Attention: Director, Transport Assessments Planning Services,  
Department of Planning, Industry and Environment  
GPO Box 39 Sydney, NSW 2001

6<sup>th</sup> May, 2020

**Re: MOD 2- The Crescent Overpass and Active Transport Links**

Figure 1-1 The revised design

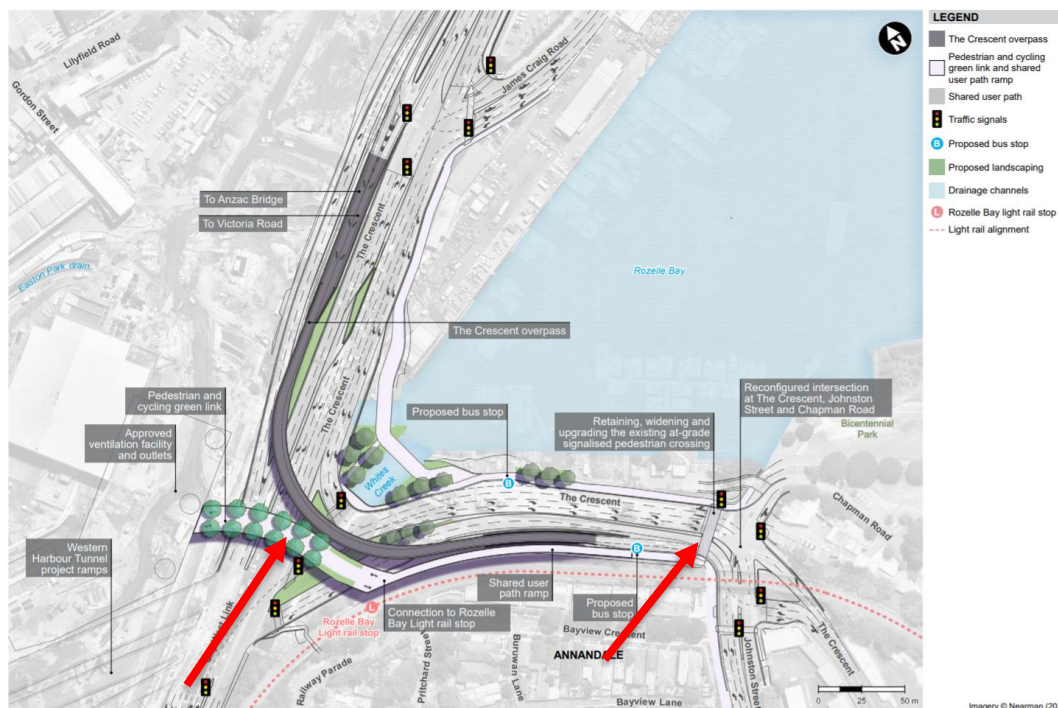
We have been assured that the crossing at Johnston Street will be widened to 6m & include bike lanterns and that the crossing underneath the overpass will have bike lanterns and be made safer for riders, and that the timing of both would be improved and enable safe crossing. This will be a great improvement, and is appreciated.

The footpath area at 300 Johnston St near the rail bridge is to be widened to take groups such as school children going to Jubilee Park. Cyclists from Chapman Rd or The Crescent path will need

some provision for continuing on Johnston St, and cyclists coming north Johnston St will need a bike lane leading to the corner, which was there until recently taken over by the utility works near 300 Johnston St. Council and the Proponent need to provide bike lanes either side of Johnston St, at least up to Rose St, where cyclists can get off Johnston onto Annandale St or other routes. If this project can't provide them, then it shouldn't prevent them being provided in future.

A shared path/bicycle path is needed from the east side of the proposed new Johnston St crossing to The Crescent and south to the current refuge crossing on The Crescent, opposite the skate park being constructed.

Figure 3-3 Broader pedestrian and cycling connectivity

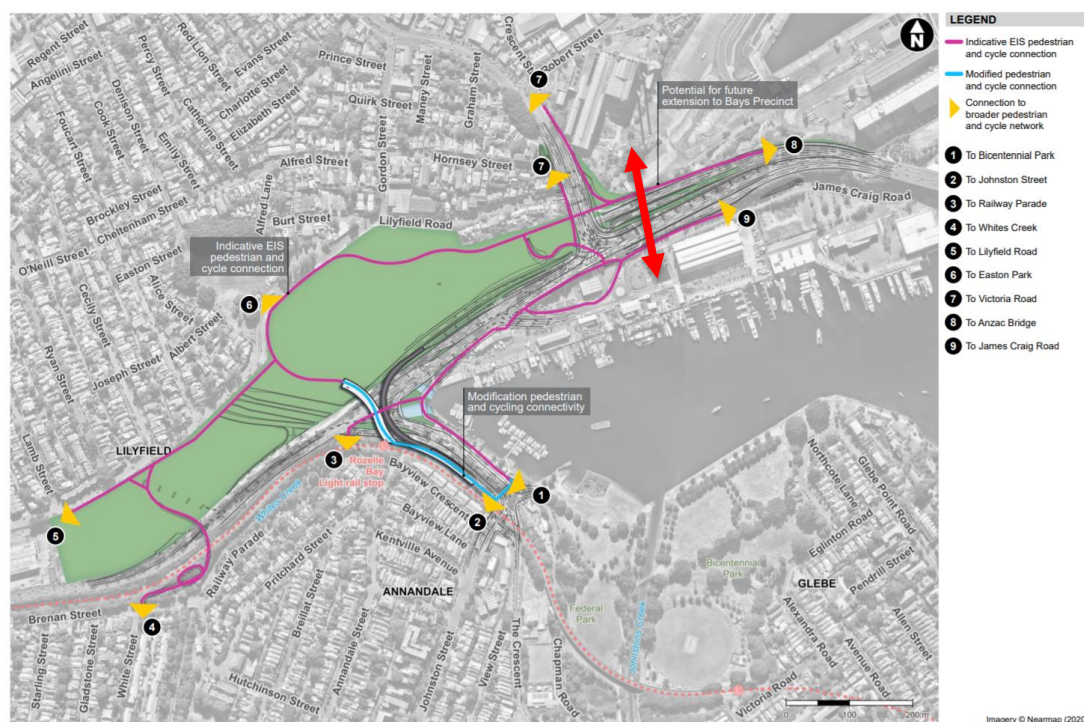
(p 49<sup>5</sup>) Removal of the u-shaped bridge does is not a significant as it was lengthy and indirect. However, we understand and share concerns about the project making it more difficult to connect to the Bays Precinct (White Bay to the light rail, Rozelle Bay, Glebe and Annandale) where it is intended that there will be high density residential development built.

We have marked with a red arrow the priority connection that needs to be built to improve direct connections essential to meet the needs of anticipated residential development.

Bicycle NSW would prefer a tunnel not an overpass to connect across the project between numbers 4 and 5 marked on the above map. This avoids the need for a 14m climb and drop, could connect in better at each side and would have less visual impact in the area for residents
